SUNDRY NOTICES AND REPORTS ON WELLS

1. Type of Well: [ ] Oil Well [X] Gas Well [ ] Other	5. Lease Serial No.: **SF-078000**
	6. If Indian, Allottee or Tribe Name: **Huerfano Unit**
	7. If Unit of CA/Agreement, Name and/or No.
	8. Well Name and No.: **Huerfano Unit 47**
2. Name of Operator: **Burlington Resources Oil & Gas Company LP**	9. API Well No.: **30-045-05971**
3a. Address: **PO Box 4289, Farmington, NM 87499** / 3b. Phone No. (include area code): **(505) 326-9700**	10. Field and Pool or Exploratory Area: **Ballard PC**
4. Location of Well *(Footage, Sec., T.,R.,M., or Survey Description)*: **Surface UNIT A (NENE), 990' FNL & 990' FEL. Sec. 09, T26N, R09W**	11. Country or Parish, State: **San Juan, New Mexico**

ConocoPhillips
HUERFANO UNIT 47
Expense - P&A

Re: Permanent Abandonment
Well: Huerfano Unit 47

Proposed Schematic

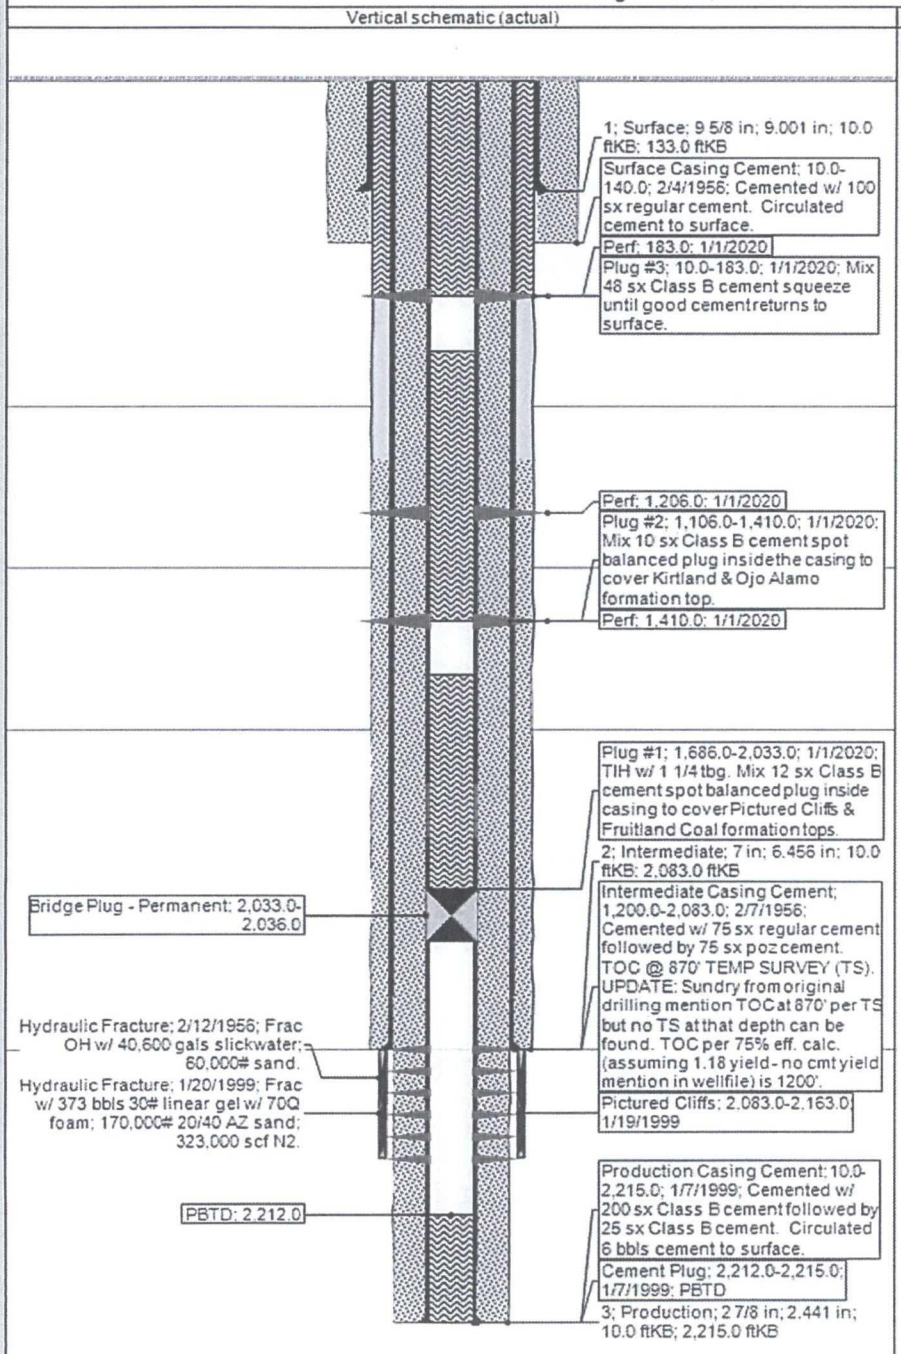
Operator will run a CBL to verify cement top. Submit the electronic copy of the log for verification to the following addresses: tsalyers@blm.gov Brandon.Powell@state.nm.us

You are also required to place cement excesses per 4.2 and 4.4 of the attached General Requirements.
